Access Compliance Report

Public Rights-of-Way

Intersection ID: 29113	Main Street: ARBOR_CREEK_DR	Cross Street: ARBOR_MEADOWS_CT	Location: S
ADA ID: FCEBDC3D3CFC	Ramp Type: PerpDiag	Initial Pass/Fail: Fail	Overall Compliance: No
Severity Score: 12.5			
Codes/Mitigation Info/Possible Solution		Field Measurements/Component Compliance

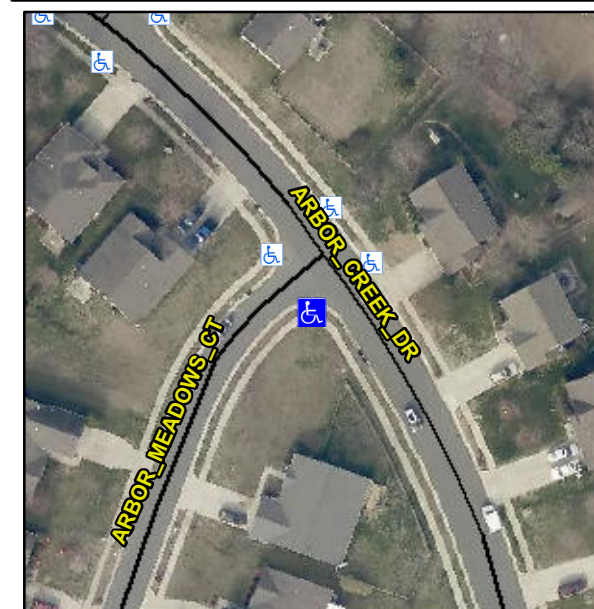
Not Found, R304.5.3

Compliance	Description	Data	Compliance	Description	Data
N/A	Ramp Length (in)	55.0	Yes	Ramp Slope (%)	6.6
Yes	Ramp Width (in)	48.0	No	Ramp XSlope (%)	5.4
N/A	Flare Type LT	N/A	N/A	Flare Type RT	N/A
N/A	Flare Slope LT (%)	N/A	N/A	Flare Slope RT (%)	N/A
N/A	Flare Traversable LT?	N/A	N/A	Flare Traversable RT?	N/A
N/A	Landing Length (in)	N/A	N/A	DWS Provided?	N/A
N/A	Landing Width (in)	N/A	N/A	DWS Contrast?	N/A
N/A	Landing Slope (%)	N/A	N/A	DWS Length (in)	N/A
N/A	Landing X Slope (%)	N/A	N/A	DWS Full Width?	N/A
N/A	Landing Curb? (Y/N)	N/A	N/A	DWS Offset (in)	N/A
N/A	Shared Landing?	N/A			
N/A	Gutter Ponding?	N/A	N/A	Gutter Slope (%)	N/A
N/A	Gutter Lip Ht (in)	N/A	N/A	Gutter X Slope (%)	N/A
N/A	Painted X Walk1?	No	N/A	Painted X Walk2?	No
	X Walk 1 Direction	To NE		X Walk 2 Direction	To NW
N/A	X Walk 1 Width (in)	N/A	N/A	X Walk 2 Width (in)	N/A
	X Walk 1 Slope (%)	0.2		X Walk 2 Slope (%)	4.0
	X Walk 1 X Slope (%)	2.3		X Walk 2 X Slope (%)	3.5

Remove & Replace Curb Ramp With Two New Directional Ramps or Equivalent.
